ARKANSAS NUCLEAR ONE, UNIT 1

AMENDMENT TO FACILITY OPERATING LICENSE

Amendment No. 93 License No. DPR-51

ARKANSAS NUCLEAR ONE, UNIT 2

HYDROGEN %
FIGURE 3.2 4-1
HYDROGEN - OXYGEN LIMITS FOR ANO-1

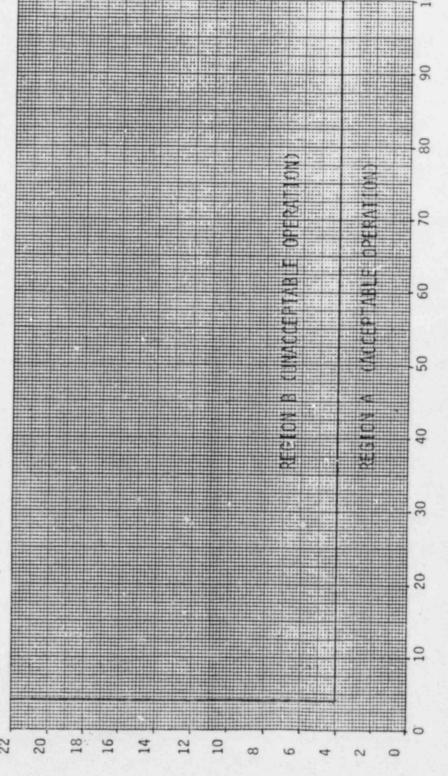
- 3.24.1 The concentration of hydrogen/oxygen shall be limited in the waste gas decay tanks to Region "A" of Figure 3.24-1.
- 3.24.2 When the hydrogen/oxygen concentration in any of the decay tanks enters Region "B" of Figure 3.24-1, corrective action shall be taken to return the concentration values to Region "A" within 24 hours.
- 3.24.3 The provisions of Specifications 3.0.3 and 3.0.4 are not applicable.

- 4.28.1 The concentration of hydrogen/oxygen in the waste gas system shall be monitored continuously by either the primary or redundant waste gas analyzer during waste gas compressing operations to the waste gas decay tanks.
- 4.28.2 During waste gas system operation, with no $\rm H_2/O_2$ analyzer in service, without delay suspend all additions of waste gas to the decay tanks or take grab samples for analysis every 4 hours during degassing operations, daily during other operations. The analysis of these samples shall be completed within 8 hours of taking the sample.

This specification is to assure that the hydrogen/oxygen concentration will be kept within the limits in Figure 3.24-1 and therefore not enter the flammable region concentrations in the waste gas decay tanks.

Grab samples are to be taken every 4 hours during degassing operations when both hydrogen/oxygen analyzers are out of service. These samples are to be analyzed within 8 hours to assure that the hydrogen/oxygen concentration is within the limits in Figure 3.24-1. During other Waste Gas compressor operations, the hydrogen/oxygen concentration is not as subject to change, therefore grab samples are to be taken every 24 hours.

HYDROGEN %
FIGURE 3.11-1
HYDROGEN - OXYGEN LIMITS FOR ANO-2
WASTE GAS SYSTEM

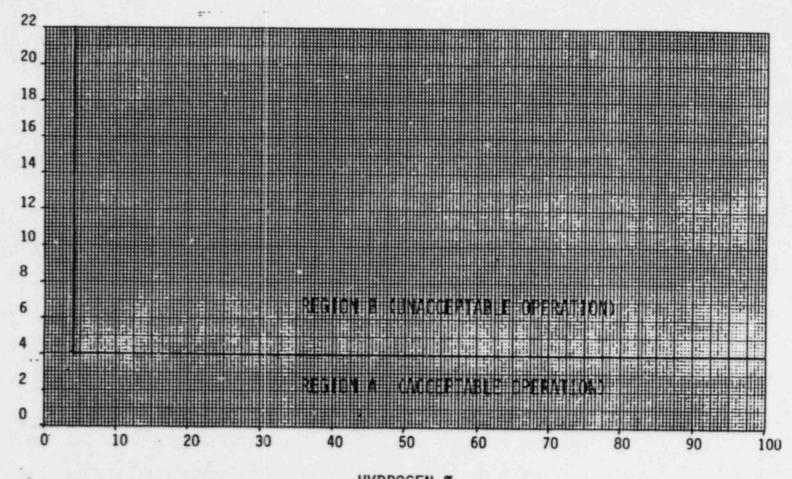
3.11.2.7 The concentration of the vdrogen/oxygen shall be limited in the waste gas storage tanks to Region "A of Figure 3.11.1.

- a. When the concentration of hydrogen/oxygen in the waste gas storage tanks enters Region "B" of Figure 3.11-1, corrective action shall be taken to return the concentration values to Region "A" within 24 hours.
- The provisions of Specifications 3.0.3 and 3.0.4 are not applicable.

4.11.2.7 The concentration of hydrogen/oxygen in the waste gas holdup system shall be determined to be within the above limits, with the waste gas system in operation, by continuously monitoring with the hydrogen/oxygen monitors required OPERABLE by Table 3.11-3.

Grab samples are to be taken every 4 hours during degassing operations when both hydrogen/oxygen analyzers are out of service. These samples are to be analyzed within 8 hours to assure that the hydrogen/oxygen concentration is within the limits in Figure 3.11-1. During other Waste Gas Compressor operations, the hydrogen/oxygen concentration is not as subject to change, therefore grab samples are to be taken every 24 hours.
